Change Order

PROJECT: (Name and address)
16751-Trenton High School Cafetorium

Change Order Number: 013

Miscellaneous changes per attached Change Order Proposals listed below:

BLDGS. 22 D.S. Connection Plan REV. 02/25/22

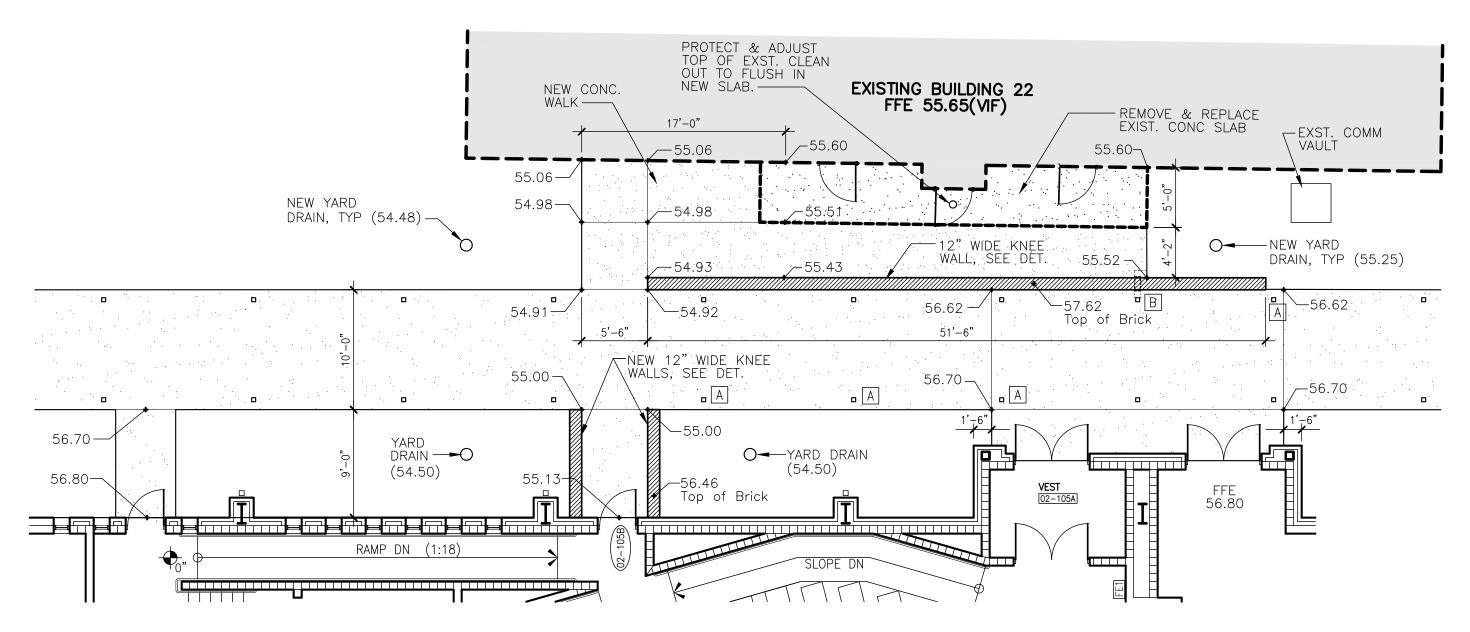
During my site visit last Wednesday, Troy confirmed the scuppers in building # 18 are sealed. The plan sketch I issued to you on January 24 in my message below, has been revised to delete all scope related to Building #18 (see attached). Please revise cost proposal for this work to include only the replacement & connection of building #22 downspouts to UGSWS.

Additionally, please see attached sketch for regrading work in area between Cafetorium and Building #22, to include:

- Adding knee walls outside door 02-105B, and along south side of Bldg. #22
- Removing existing concrete pad on south side of Bldg. 22, and replacing with expanded concrete paved area as shown.
- Adding yard drains south of Bldg. #22 as shown.
- Construct and grade area per revised grade elevations shown.
- Coordinate covered walk downspout drainage directions in this area as shown.

KNEE WALL DETAIL

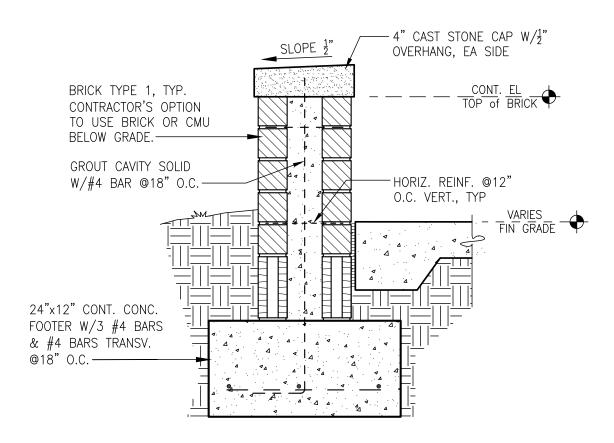
- ALUM. CANOPY FRAME COLUMN. D.S. DRAIN THIS SIDE ONLY. NOTCH SIDEWALK FROM COLUMN TO NEAREST EDGE FOR POSITIVE DRAINAGE, SIM DET 6/AO.3.
- B ALUM. CANOPY FRAME COLUMN. D.S. DRAIN THIS SIDE ONLY. PROVIDE PVC THRU-WALL SLEEVE, AND NOTCH SIDEWALK ON EA. SIDE OF SLEEVE FOR POSITIVE DRAINAGE INTO SLEEVE, AND TO EAST EDGE OF SLAB ON NORTH SIDE OF KNEE WALL.

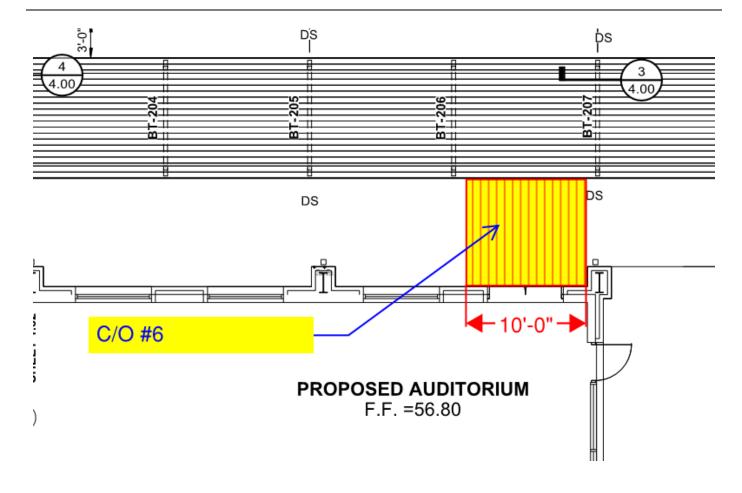
In keeping with your discussions with our Bill Wittenbrook and the instruction to add a 10' wide canopy connector at door 02-101G (see attached for location), we submit this change proposal

BLDG 2 WEST MEZZANINE HVAC DUCTWORK PLAN SCALE: 1/4" = 1'-0"

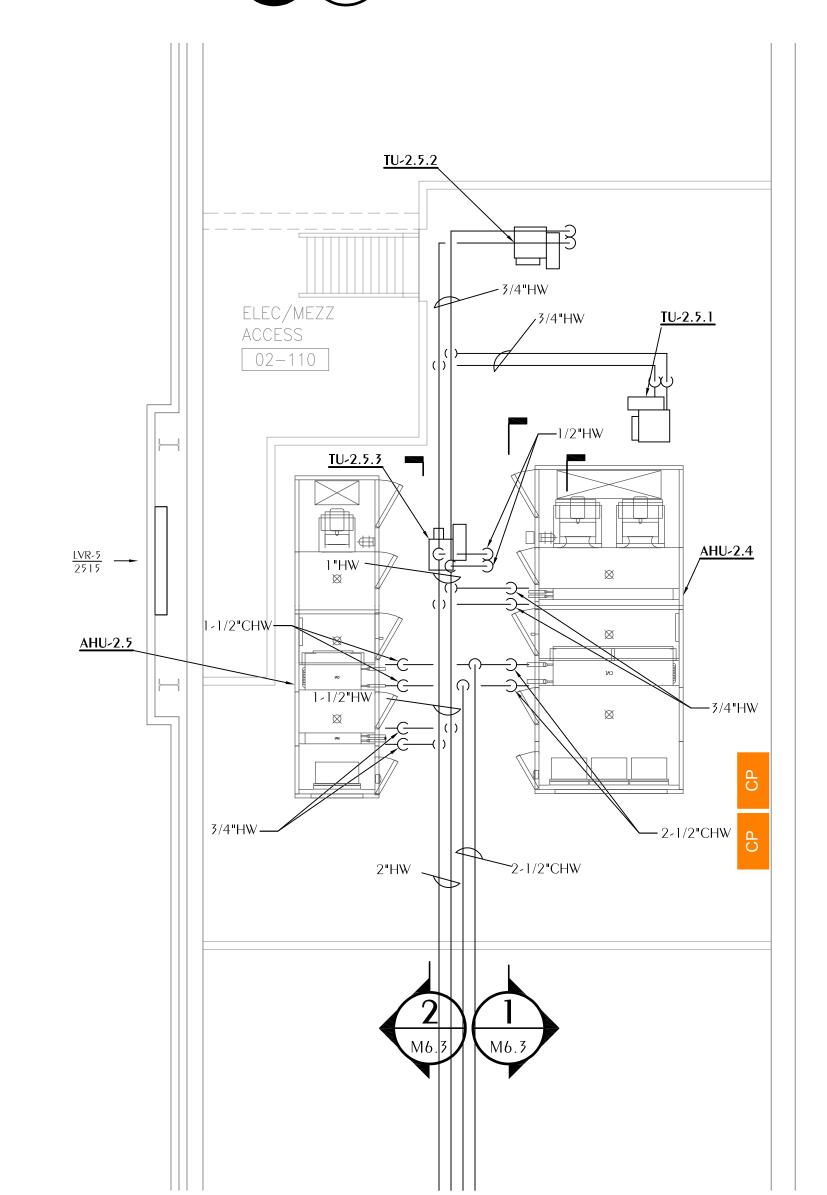
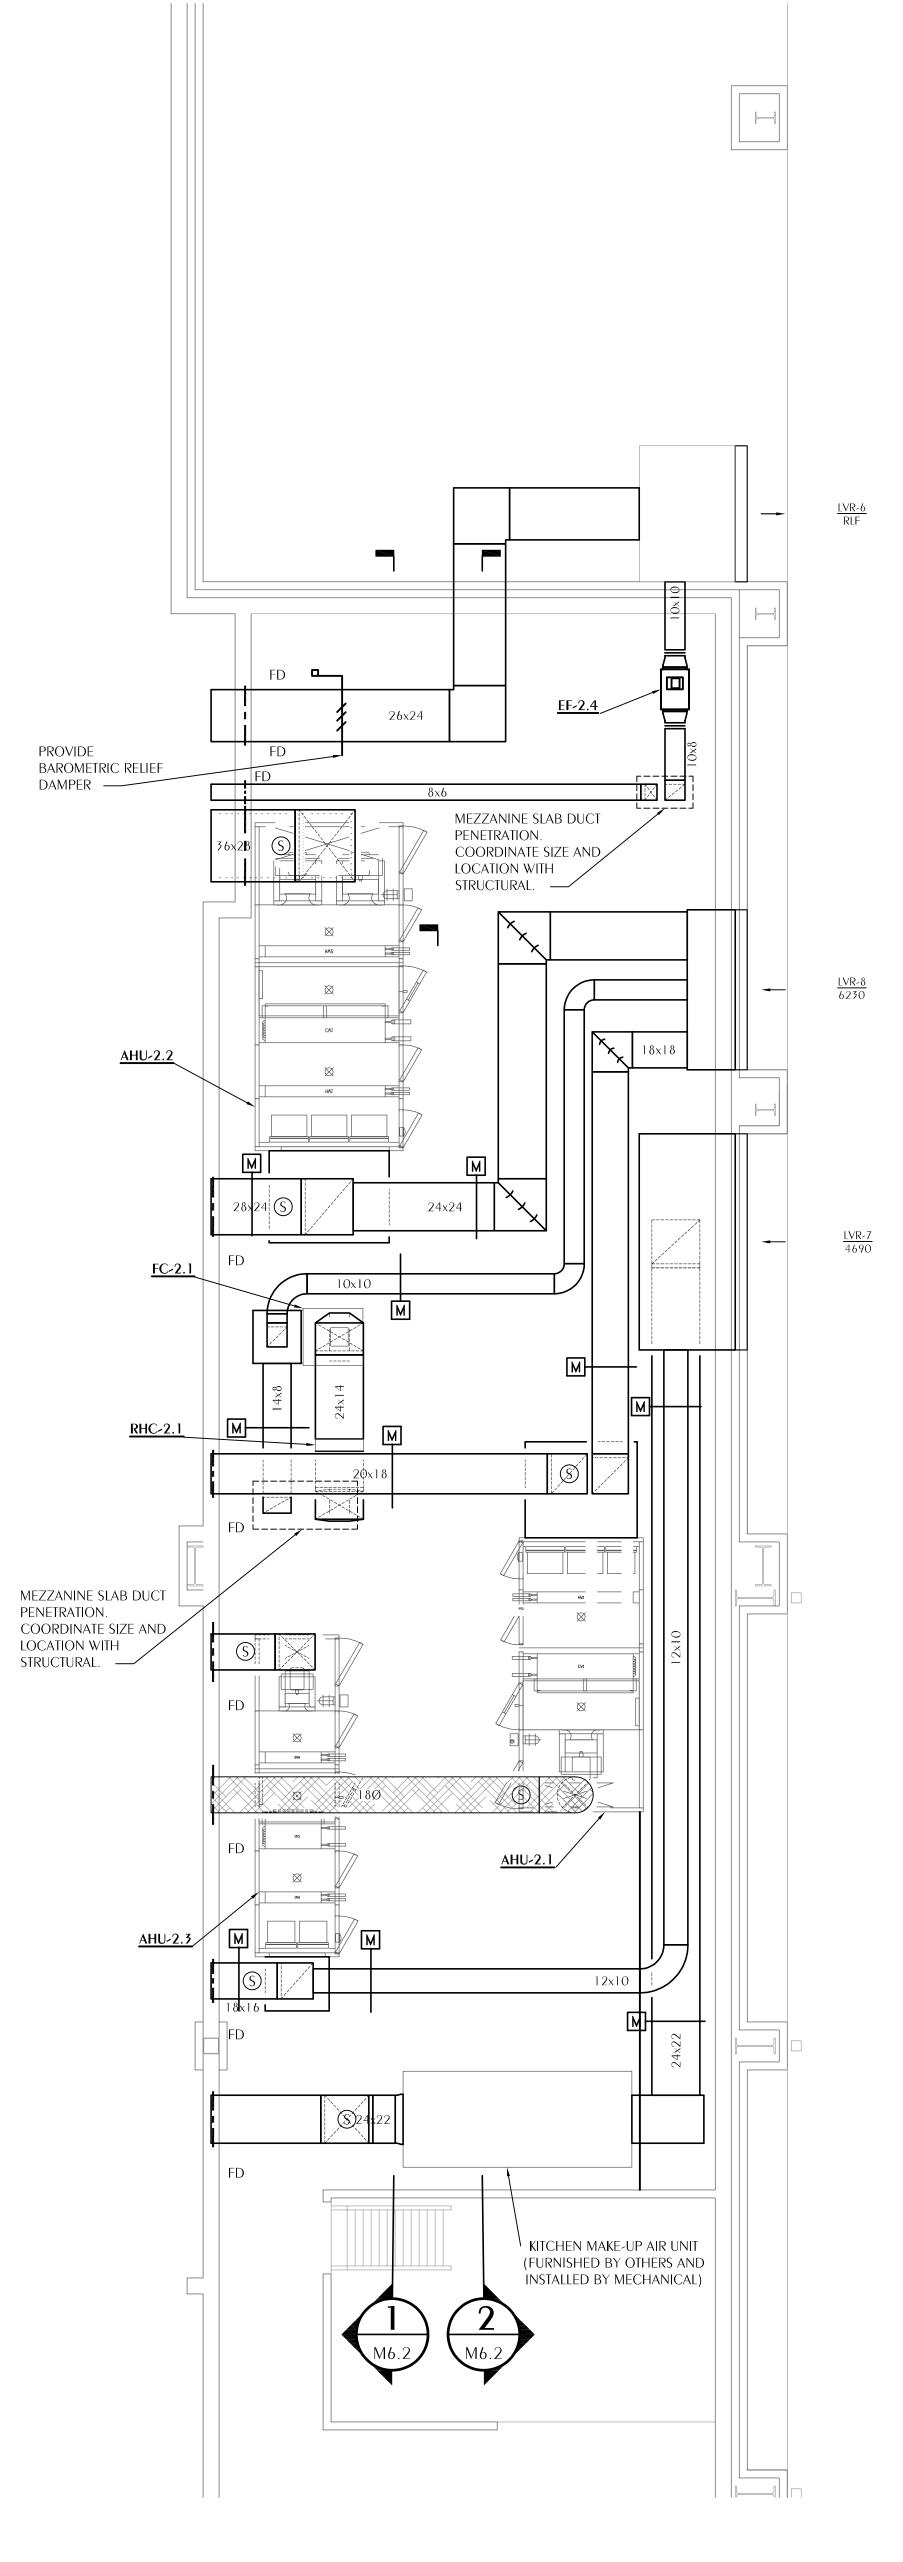
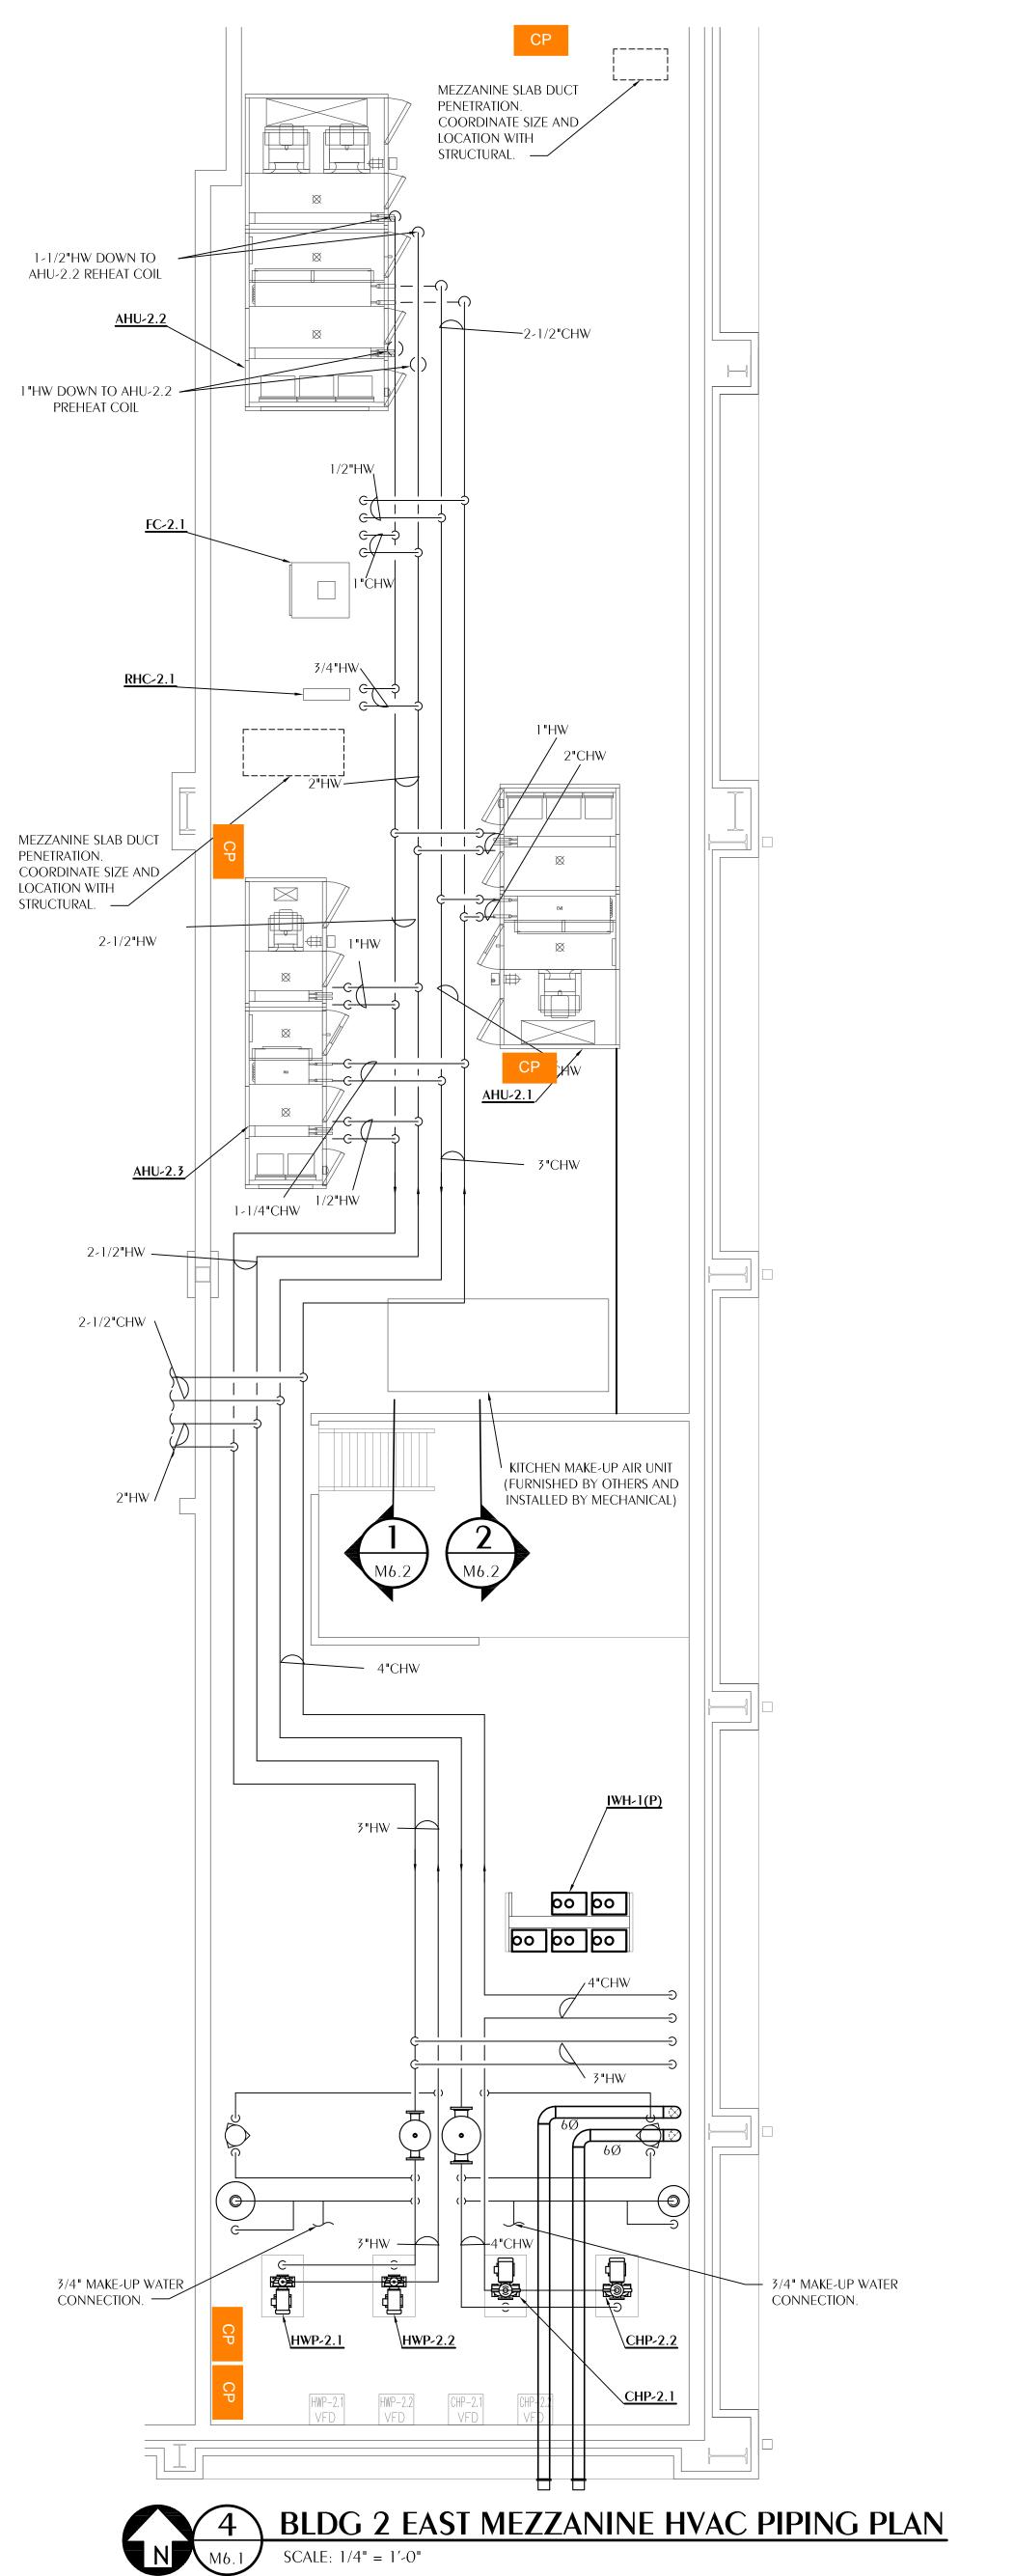
Indicates locations of control panels determined by Johnson Controls, not shown on plans.

Question: Given these locations, from what panel would these control panel be fed and on what

QUESTIONS IN THIS RFI APPEAR TO BE SAME AS ONES INCLUDED IN RFI #122. VERIFY QUESTIONS & RESPONSES IN BOTHS RFI'S ARE COORDINATED.

RESPONSE BELOW IS SAME AS GIVEN BY HGE IN RFI #122:
